To: Members of Dublin City Council
From: Marsha I. Grigsby, City Manager *MA*
Date: October 4, 2012
Initiated By: Steve Langworthy, Director of Land Use & Long Range Planning
Re: Final Plat – Ballantrae, Section 9, Phase 1 (Case 06-153FDP/FP)

4. **Final Development Plan/Final Plat 06-153FDP/FP – Dublin Golf Community – Ballantrae, Section 9 – Lots 615 through 654 – Barronsmore Way**
Location: 17.0 acres located on the east side of Cosgray Road, approximately 1,000 feet south of Larne Drive.
Existing Zoning: PLR, Planned Low Density Residential District (Dublin Golf Community Plan, Subareas I and X).
Request: Review and approval of a final development plan and a final plat under the PD provisions of Code Section 150.050.
Proposed Use: A single-family subdivision of 40 lots and 2.7 acres of open space.
Applicant: Charles Driscoll, Edwards Golf Communities, LLC., 495 South High Street, Suite 105, Columbus, Ohio 43215.
Staff Contact: Claudia D. Husak, AICP, Planner.
Contact Information: (614) 410-4675/chusak@dublin.oh.us.

06-153FDP/FP
Final Development Plan/ Final Plat
Ballantrae Section 9

PROPOSED FINAL PLAT

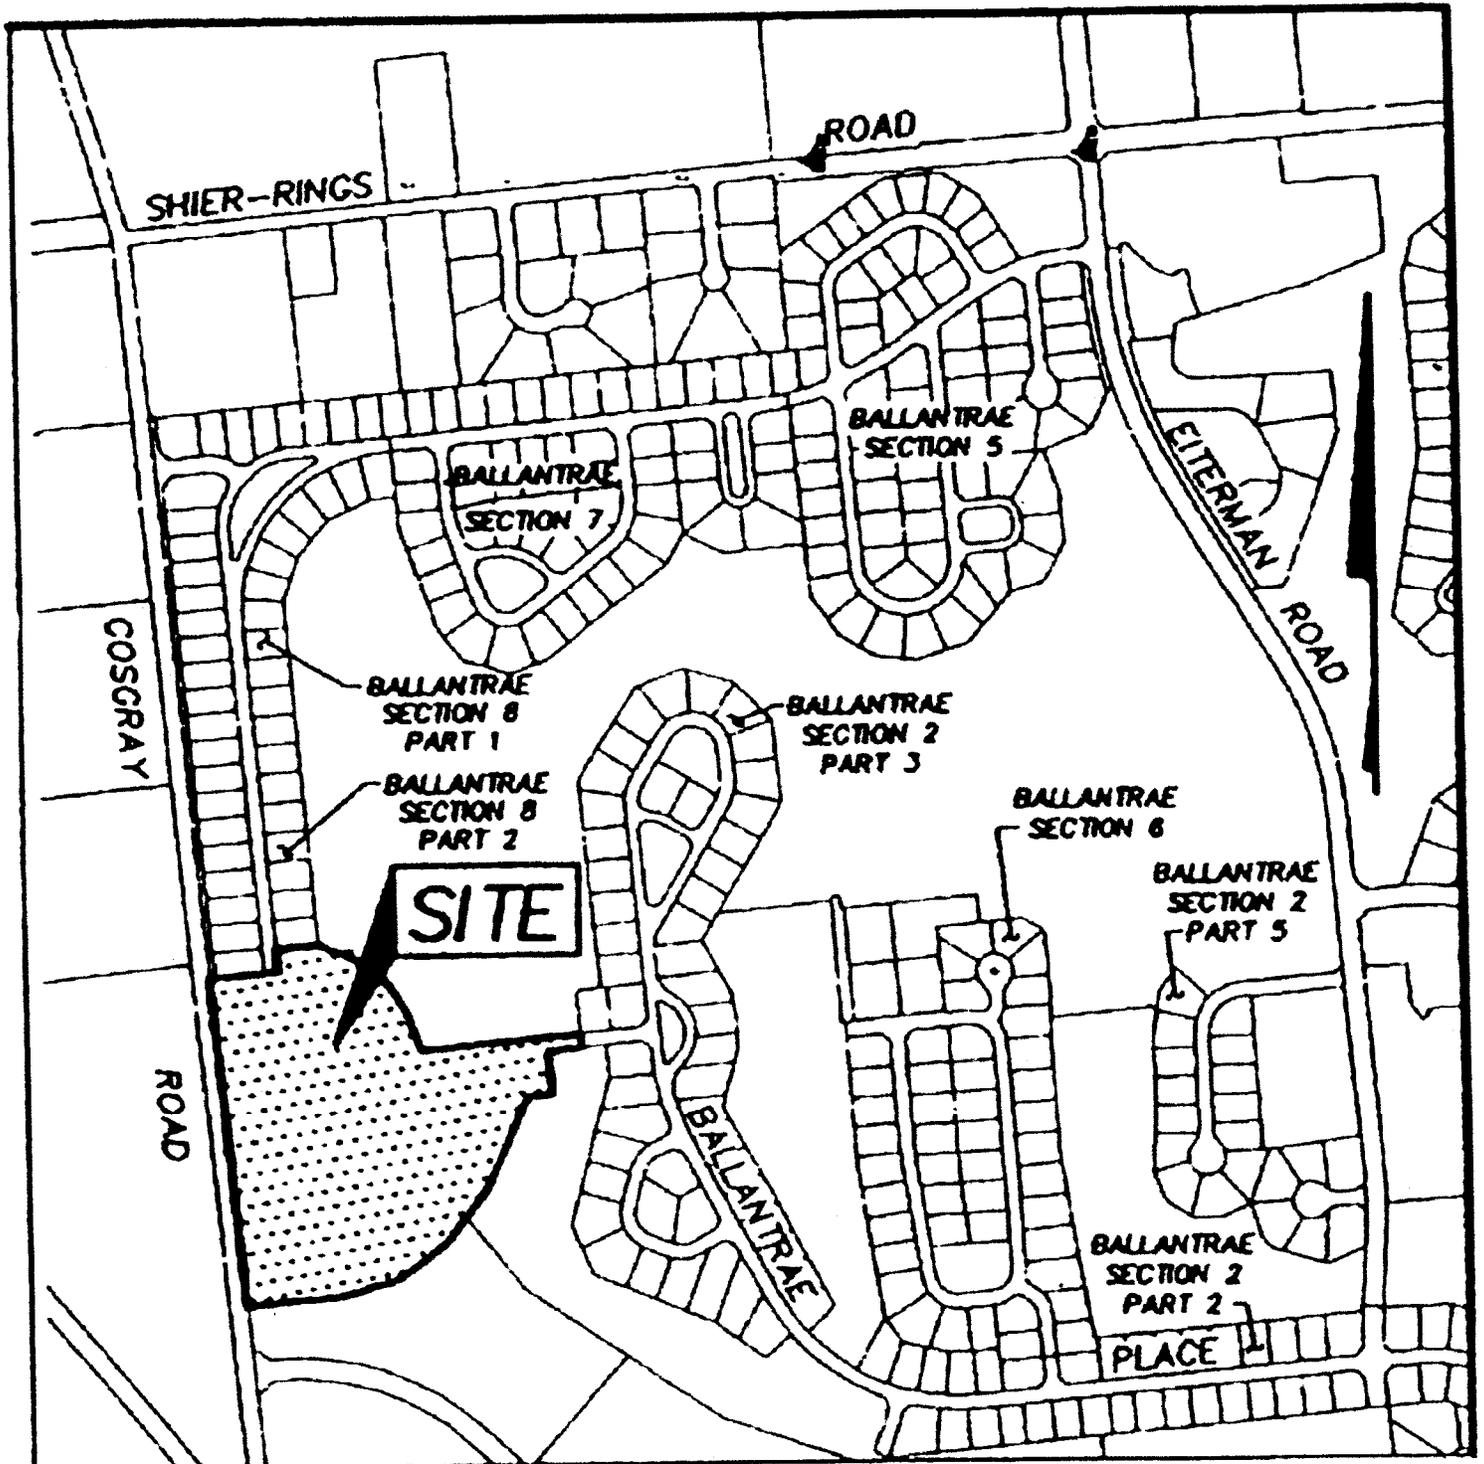
Planning has noted inconsistencies in the labeling of the plat, such as a 30-foot building line indicated along the front of Lot 624 line actually scales 35 feet. Planning recommends that all technical plat adjustments be submitted prior to scheduling a hearing at City Council. (Condition #1)

- 1) That the technical plat adjustments be submitted prior to scheduling a hearing at City Council;
- 2) That the location of activity areas in the park be adjusted to avoid potential conflicts with utility easements prior to filing for a building permit, subject to Planning and Engineering approval;
- 3) That utility provider information not be required on a per lot basis, as previously required by condition, but be noted on the plat, and the that the applicant supply such information in the sales office; and
- 4) That that the deficient parkland of 0.808-acre be remedied by dedicating the land in Subarea S, at the final development plan stage.

PROPOSED PARK LAYOUT

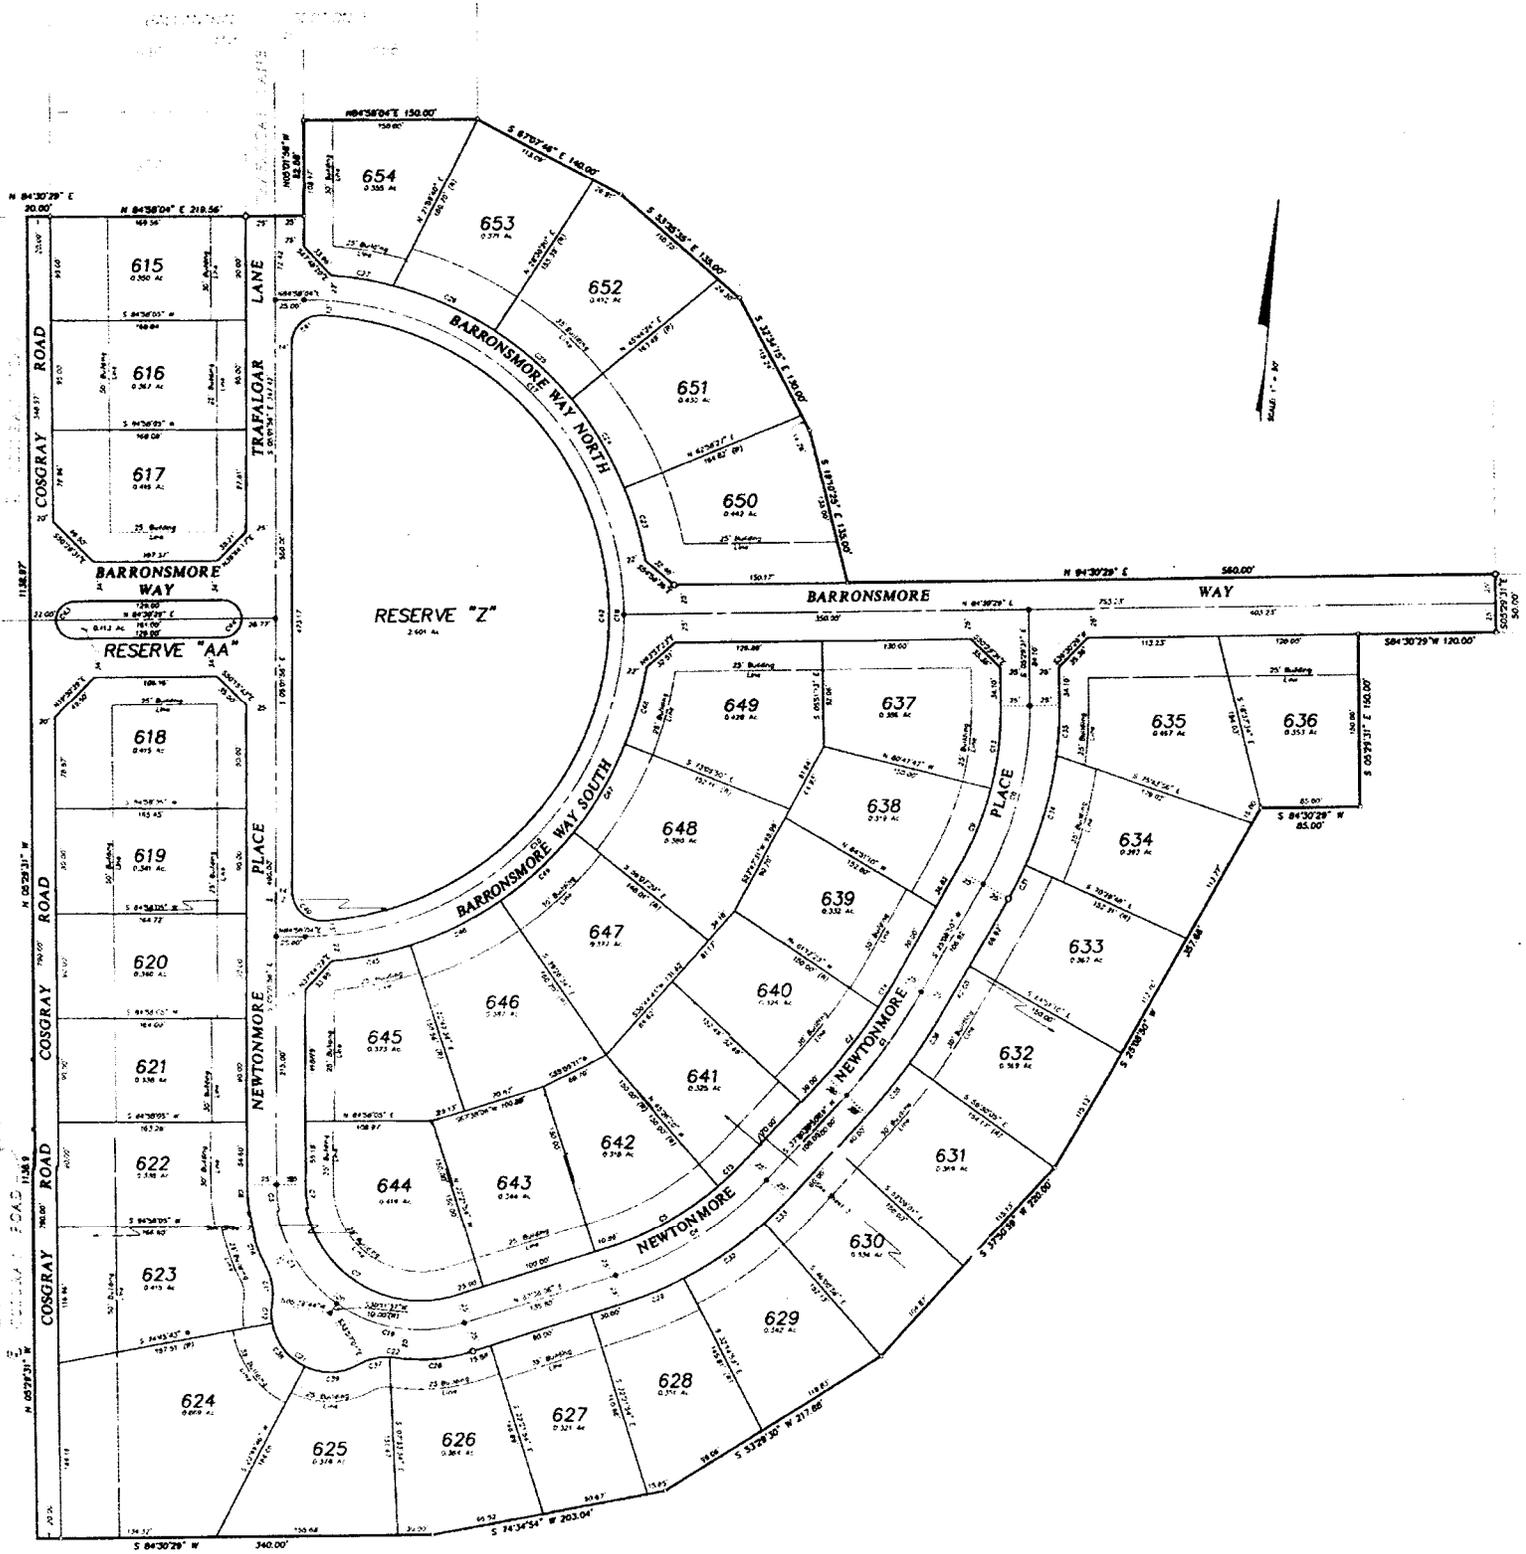
The proposed programming for the park includes rubble walls gravel paved areas with benches. Planning is concerned that the proposed areas of activity may be in conflict with utility easements for storm and sanitary sewers. A minor adjustment to the location of

the rubble walls and the gravel paved areas will alleviate any conflicts. Planning recommends that the applicants make these adjustments prior to filing for a building permit. (Condition #2)
